Groundwater Application Review Summary Form

Application # G- 18648

PUBLIC INTEREST REVIEW FOR GROUNDWATER APPLICATIONS

SUBJECT: Application G- 18648 Supersedes review of NA*
Date of Review(s)

Figure 3. Water-Level Trends in Nearby Wells

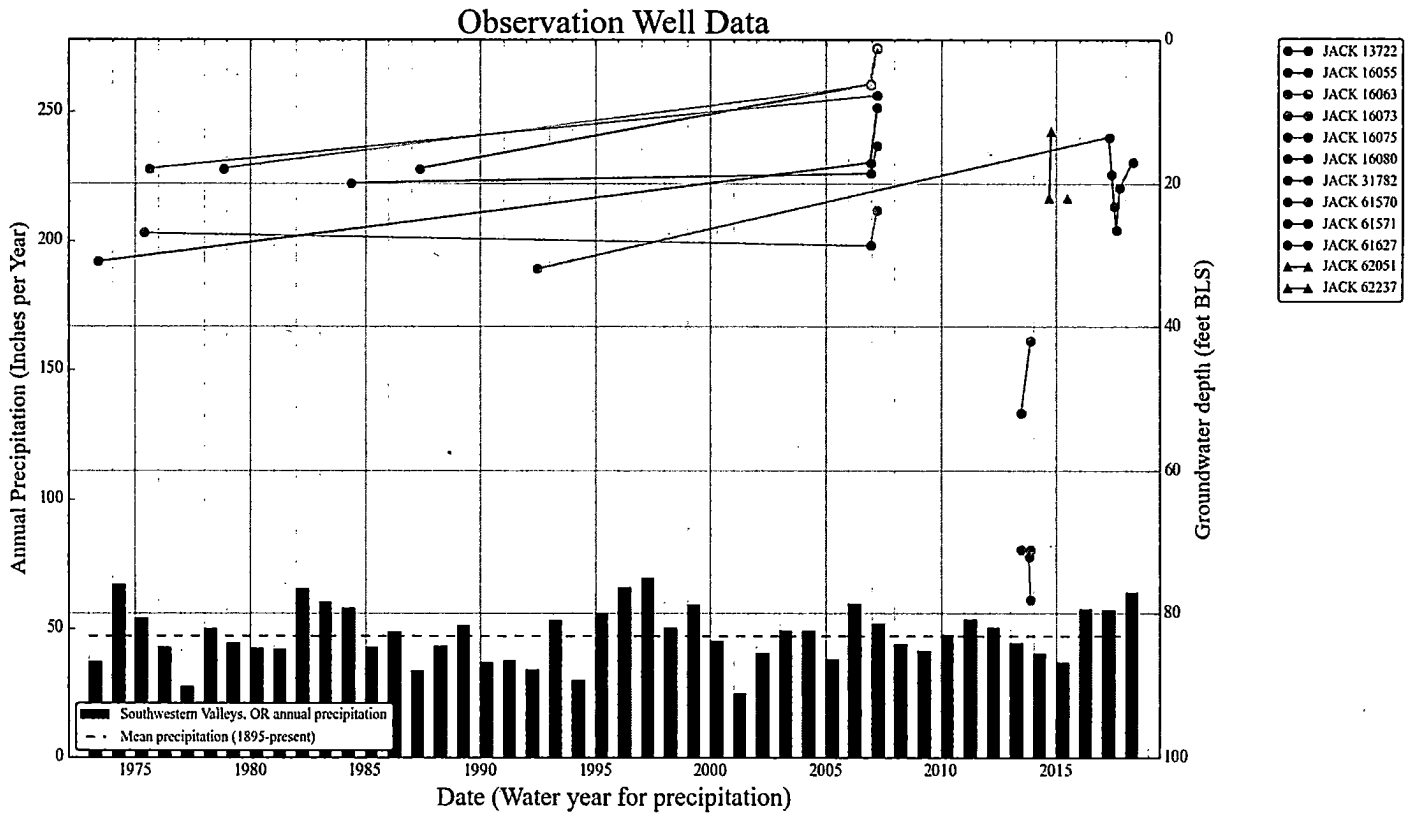
B3. **Groundwater availability remarks:** The applicant's well would produce from a fractured bedrock aquifer system in metasedimentary units of the Applegate Group. SWL measurements in nearby wells appear stable but lack the continuity to provide a preponderance of evidence that the resource is or is not over-appropriated (see Figure 3).

There is moderate groundwater development to the northwest, but considering the requested rate and the nature of the aquifer (decomposed bedrock and local fracture systems), it is unlikely the proposed use will cause injury to senior users. There is a POA located less than 300 feet to the west (GR-2241), but it is located on the same tax lot. There is a likelihood of well-to-well interference, but because they have the same owner, this review does not consider the potential injury or interference to this particular POA.
